# Recall Campaign

INT FL769-01/02

## Subject: TBB SynTec S3B Seat Frames (Restraint Seats)

**Models Affected: Thomas Built Buses Saf-T-Liner C2, EFX, and HDX buses and Minotour buses manufactured August 27, 2014, through February 5, 2018.**

Figure 3

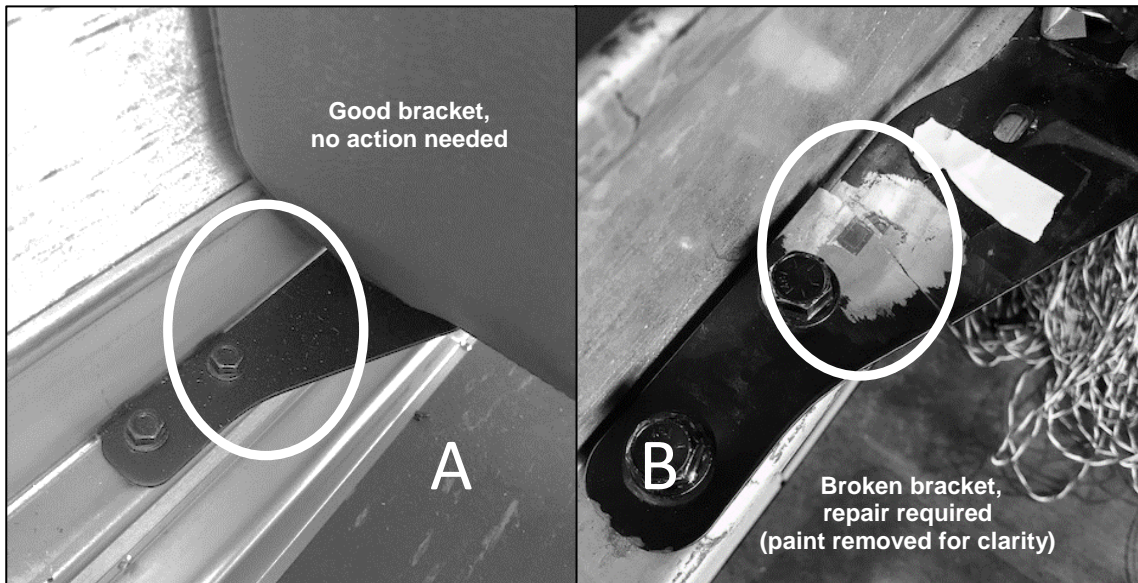
2. Is the bracket intact? Is the bracket cracked or broken? See **Figure 3, Items A and B.**

If a cracked or broken seat mounting bracket is found, please contact your Thomas Built Buses dealer as soon as possible to have it repaired at no charge.

**Figure 2: Seat Mounting Hardware**

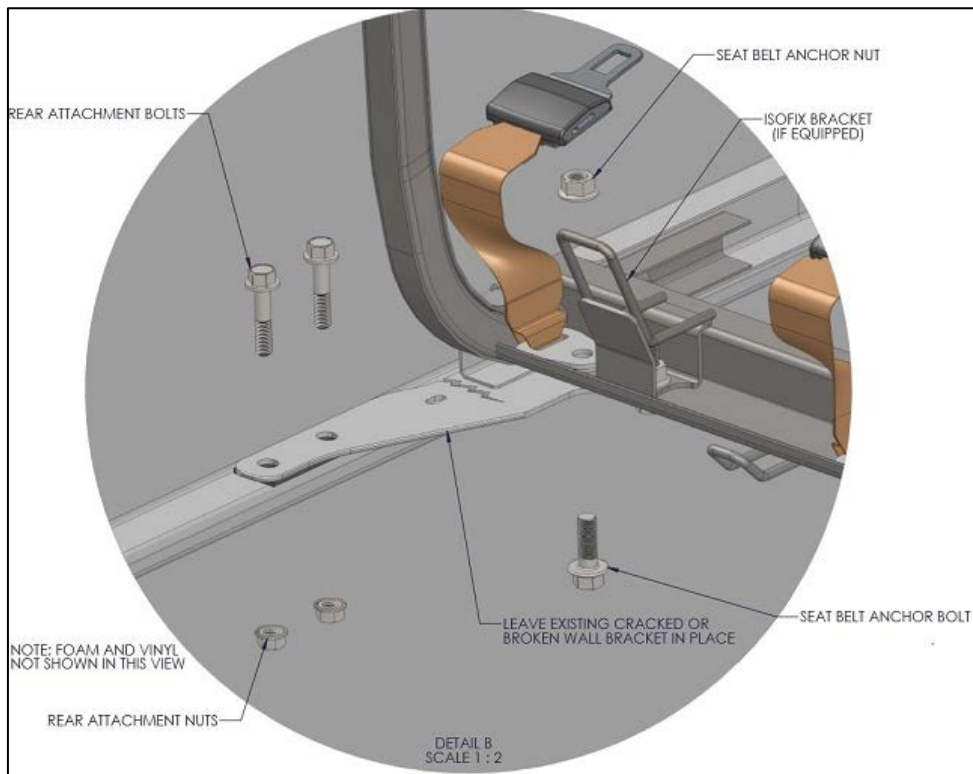
3. Remove the rear seat rail nut and bolt using a 9/16 inch socket, swivel adaptor, and an open-end wrench. Retain hardware for reinstallation. See **Figure 2**.

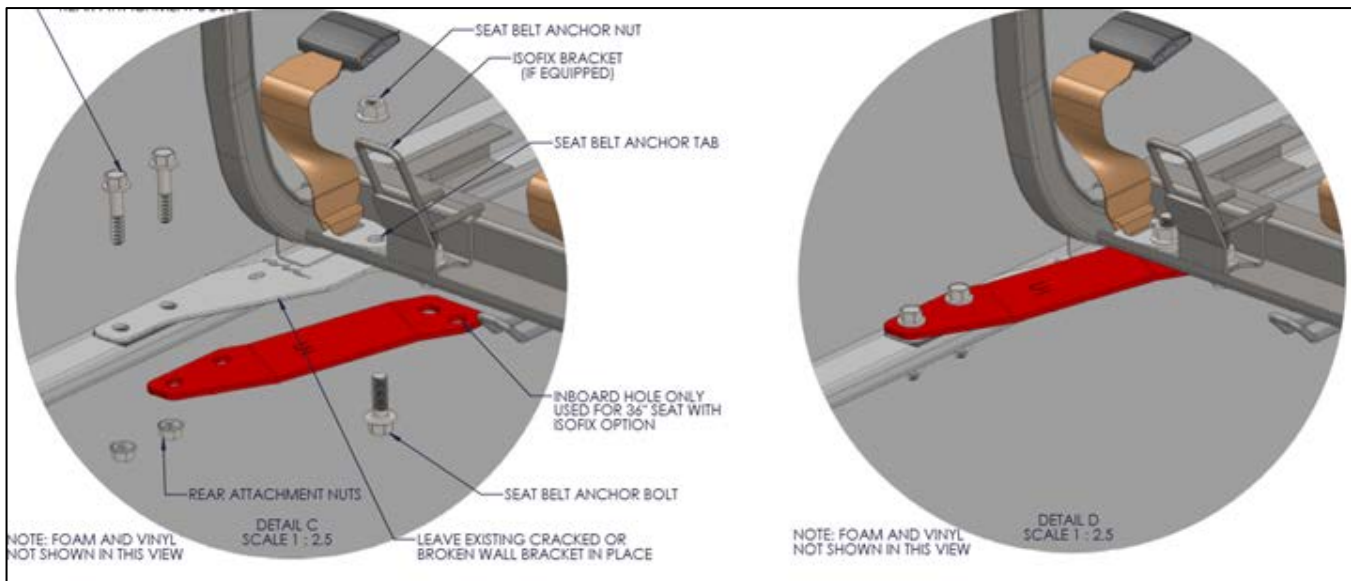
4. If there is a seat belt in the position next to the bus wall, remove the bolt and nut and discard. Retain the seat belt for reinstallation.
5. If the seat has an ISOFIX, remove it and retain the bracket and mounting hardware for reinstallation.
6. Place the new bracket over the existing, broken bracket. Reposition the broken piece to its original placement, if needed. Install the reinforcement bracket as shown in **Figure 3**.

7. If a seat belt was removed earlier, reinstall it using the new nut and bolt supplied in the kit and torque to 45 lbf.lbs.

NOTE: The inboard hole in the reinforcement bracket will be used only when the seat has an ISOFIX.

8. If the seat has an ISOFIX, reinstall it through the new reinforcement bracket and seat frame, tighten to 45 lbf.lbs.
9. Torque the two rear attachment bolts and nuts to 12 lbf.lbs.
10. Install the seat cushion.
11. If more than one bracket is cracked or broken, repeat this procedure for each cracked/broken bracket. (This is expected to be rare.)
12. Remove the chocks from the tires.
